| 2. AMENDMENT/MODIFICATION NUMBER 0008 | 3. EFFECTIVE DATE 04-07-2021 | 4. REQUISITION/PURCHASE REQ. NUMBER | 5. PROJECT NUMBER (if applicable) 618-17-127 |

PROJECT NAME : Renovate MH Ward 1L, 1H and 1K

VA Project: **Renovate MH Ward 1L, 1H, and 1K**

VA Addendum Items: Revision Set 3

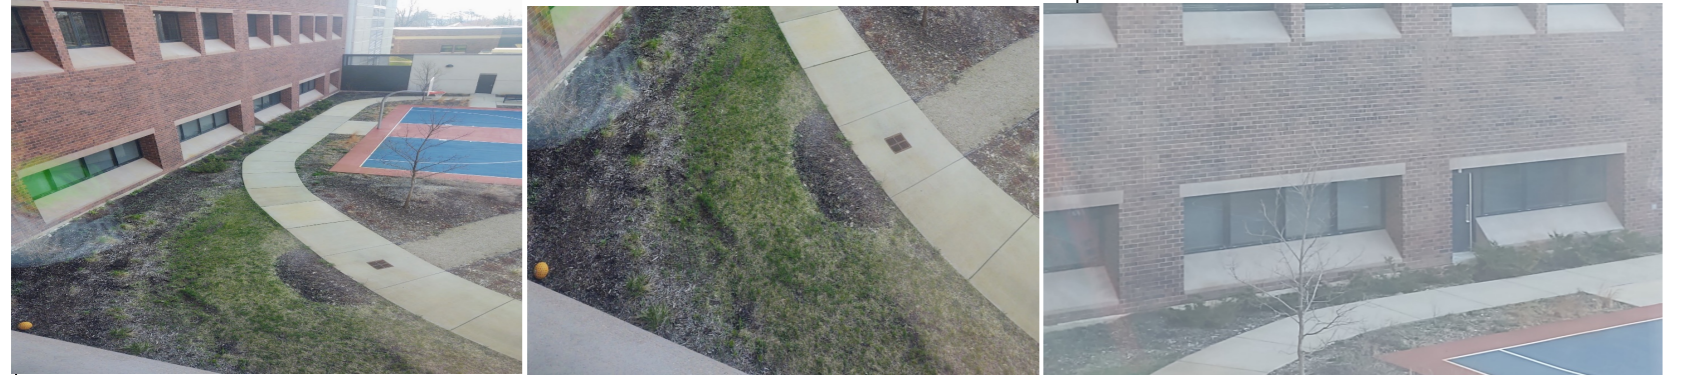
| Description | Response |
|-------------------------------------------------------------------------------------------------------------------------------------------------------------------------------------------------------------------------------------------------------|-----------------------------------------------------------------------------------------------------------------------------------------------------------------------------------------------------------------------------------------------------------------------|
| |  <p>Areas of new work circled in red, area in yellow needs temporary sidewalk installed at Phase 1 and removed after Phase 2. All other areas existing</p> |
| Is that circular sidewalk in light grey shown on the sketch a new sidewalk or existing? | |

SHEET A102: Delete O.H. Coiling Door 1L-136 from Floor Plan. Delete O.H. Coiling door 1L-135 from Floor Plan.

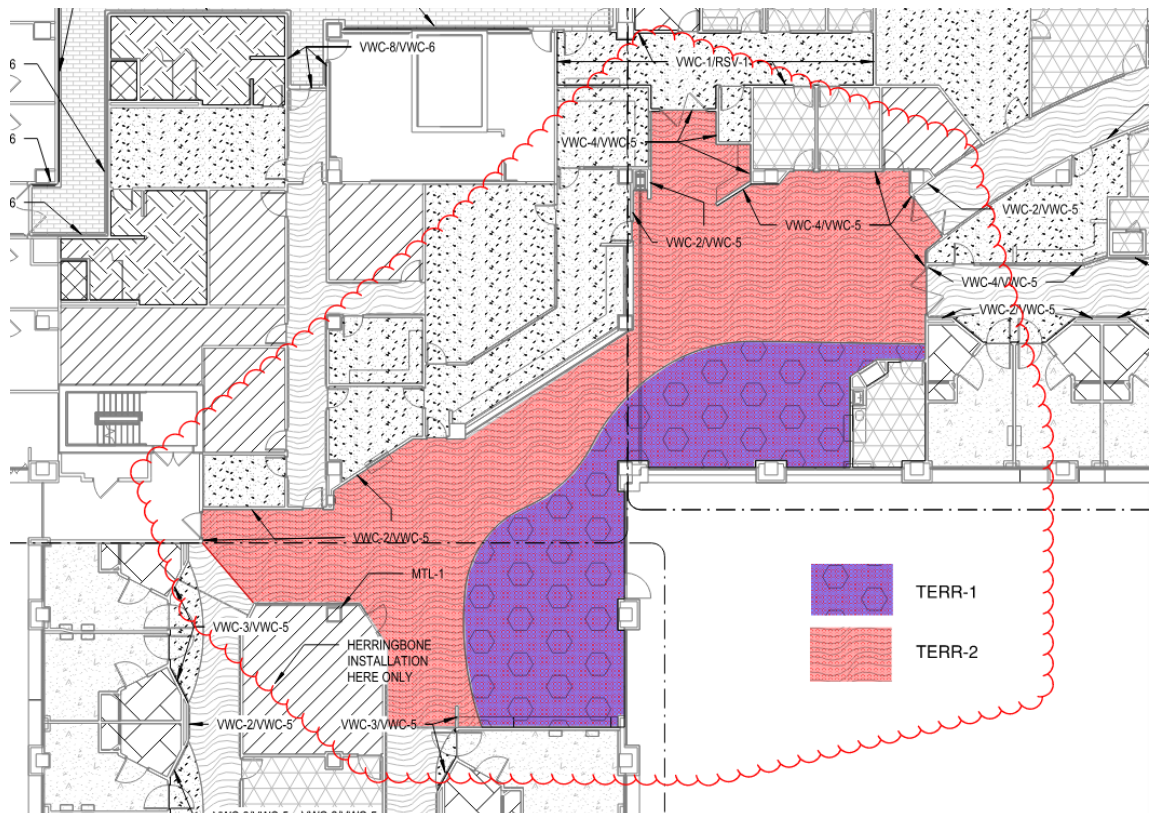
SHEET AF-001: Architectural Finish Plan, Change:

- a. **WSF-3 to TERR-1** per drawing below (Color TBD).
- b. **LVT -2 to TERR-2** per drawing below (Color TBD).
